PLANNING BOARD

To: Brookline Board of Appeals
From: Brookline Planning Board
Date: May 14, 2015
Subject: Remove existing two-car garage, construct three-car garage and new deck over garage
Location: **135 University Road**

Atlas Sheet:	41	Case #:	2015-0027
Block:	210	Zoning:	T-6
Lot:	22	Lot Area (s.f.):	6,497 sf

PROPOSED - REVISION REQUESTED

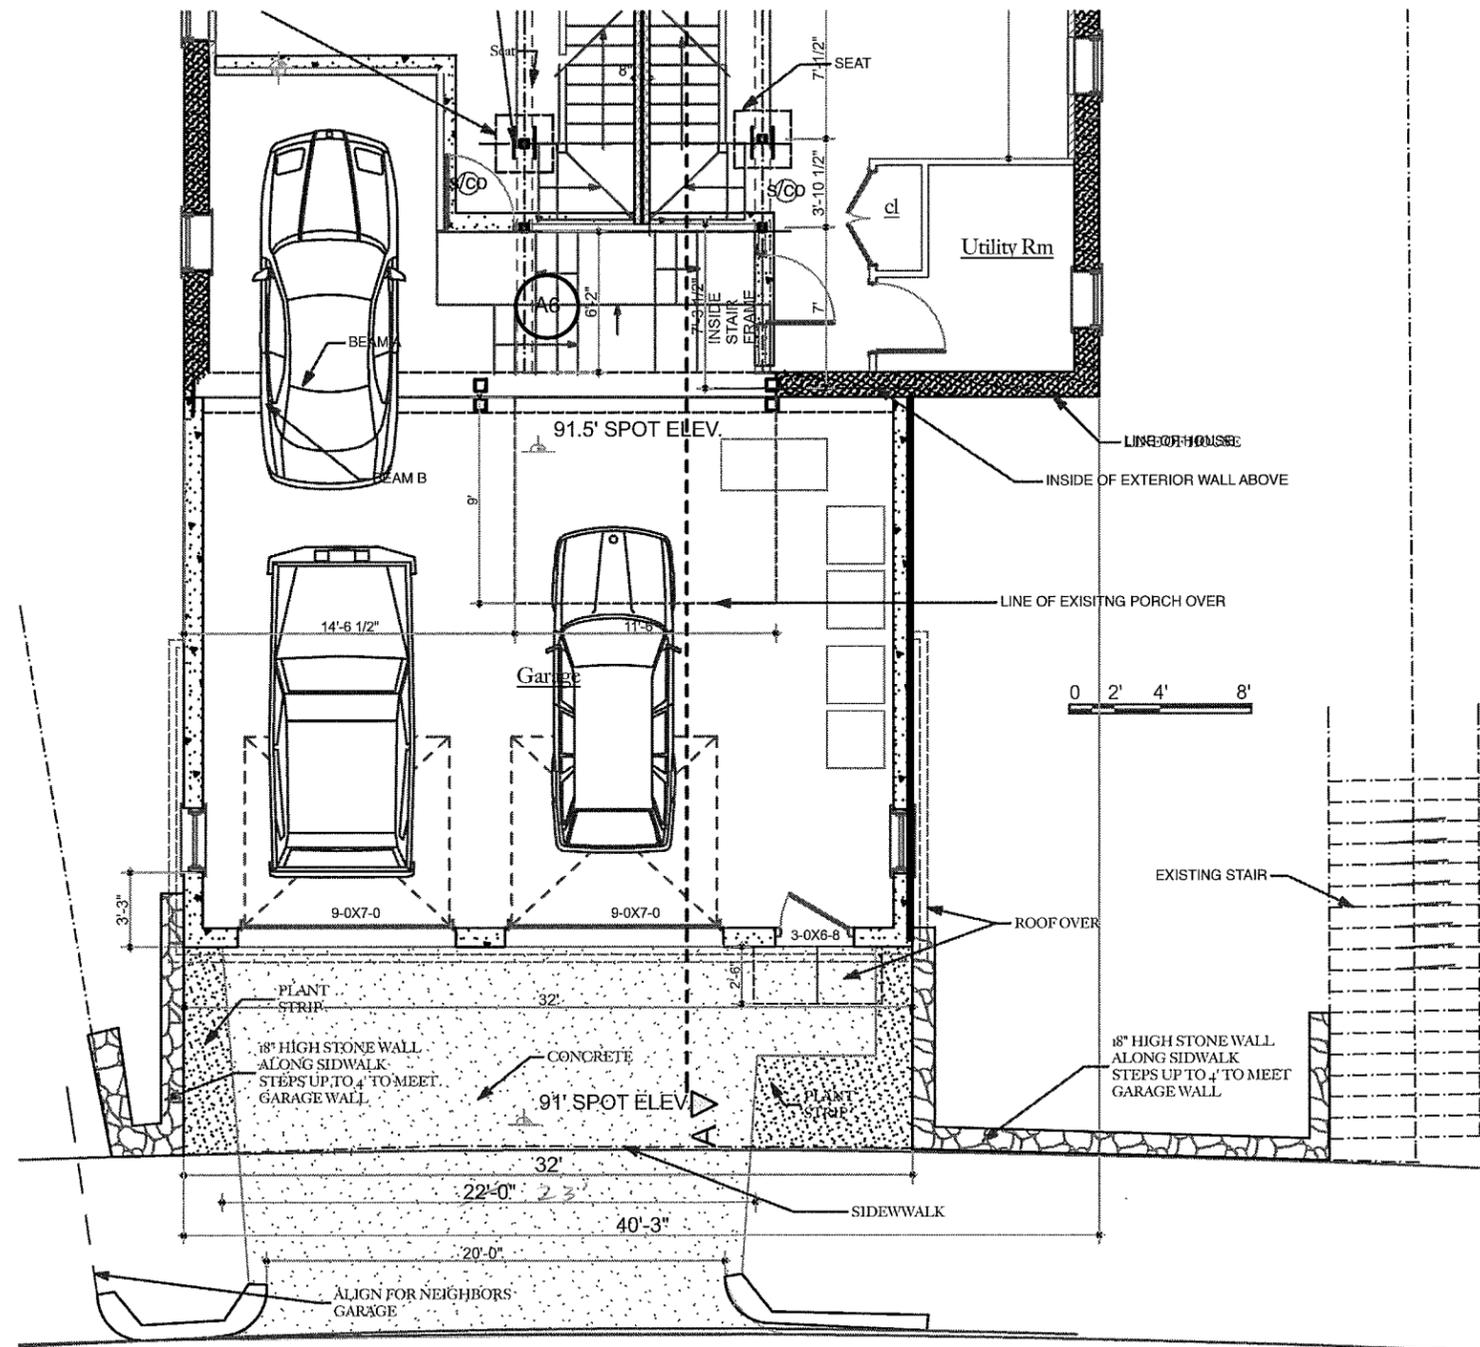
The entrance of the garage would be 8.8 feet from the front property line, which requires relief. (Under Section 5.01, Footnote 1, the entrance of a garage that faces the street must be at least 20 feet from the street lot line.) The proposed driveway would be relocated with one curb cut extended and the other closed and re-located so that the width of the driveway would be no greater than 20 feet, the maximum allowed under Section 6.04.14. (*Note:* The site plan will be updated to show the existing and proposed curb cuts, and the width of proposed driveway to be 20 feet—to be consistent with Sheet A1 “floor plan” and in compliance with Section 6.04.14.)

As noted, the site plan will need to be revised to show the proposed curb cuts and a driveway no wider than 20 feet.

Curb cut to be extended when proposed garage and driveway are moved right and left facade of garage aligns with left facade of house. Existing curb on the left to be closed and relocated so that width of driveway is 20 feet max at the street line.

1. Prior to the issuance of a building permit, a revised site plan showing proposed curb cuts and final plans and elevations indicating dimensions and materials shall be submitted subject to the review and approval of the Assistant Director of Regulatory Planning.

SECTION

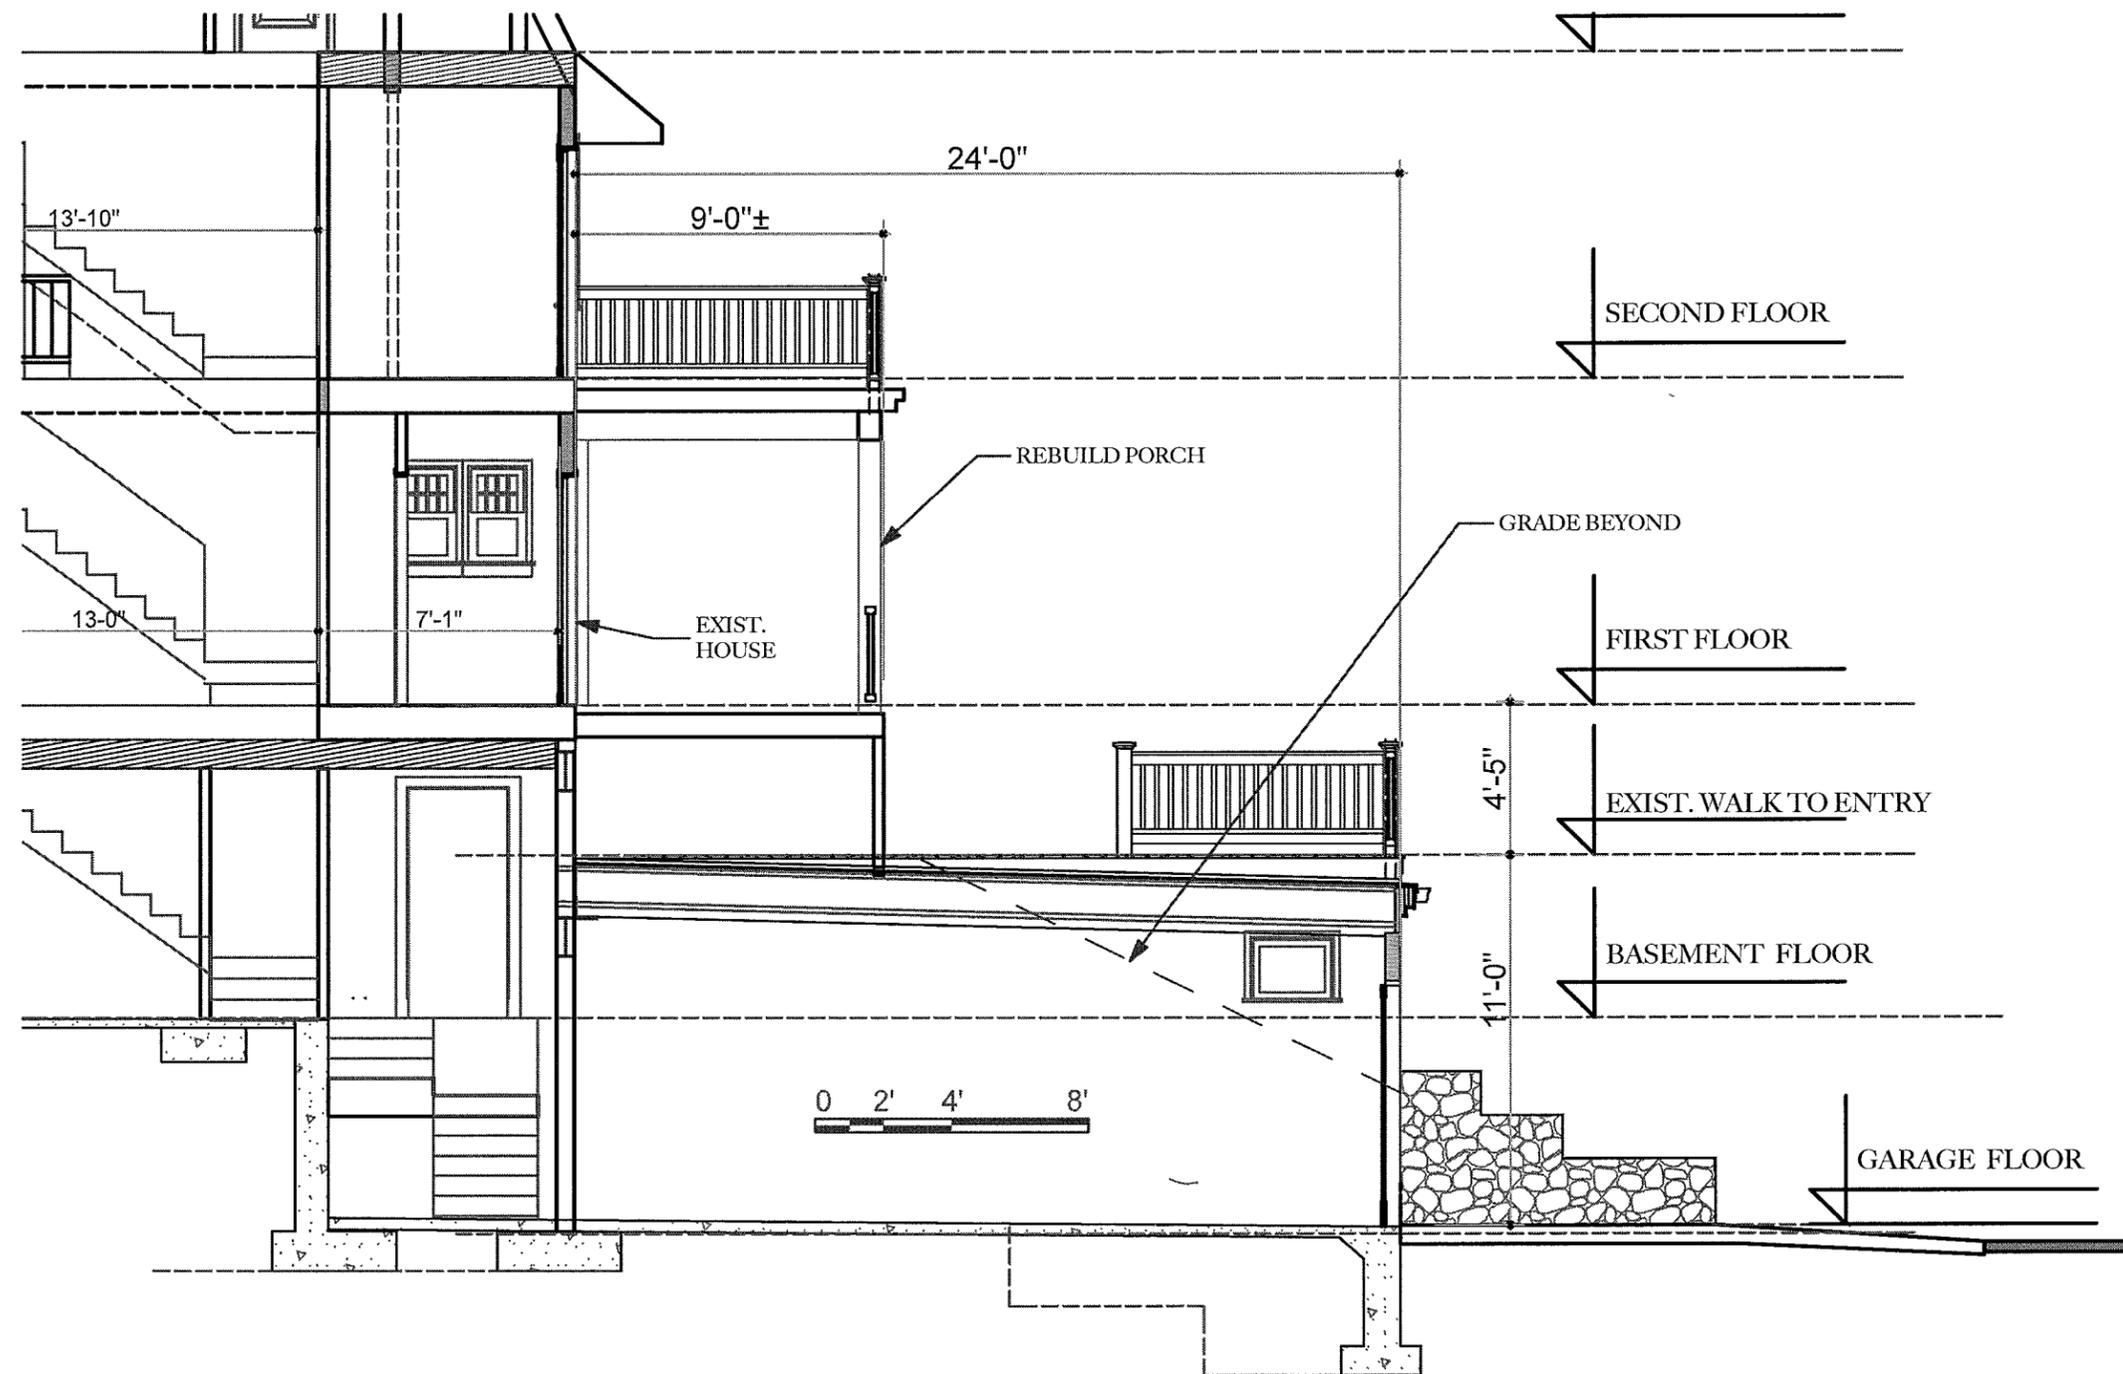
Two parking spaces would be side by side; the third space would be tandem to the parking space on the left. This tandem spot would be constructed so that the depth of the below-grade garage would now extend under the basement about 15 feet (see Sheet A3 “Building Section”). The overall depth for the two tandem spaces is 37 feet (measured from the interior walls); see Sheet A1, which shows the parking layout and parking space dimensions. This depth should be adequate for tandem parking.
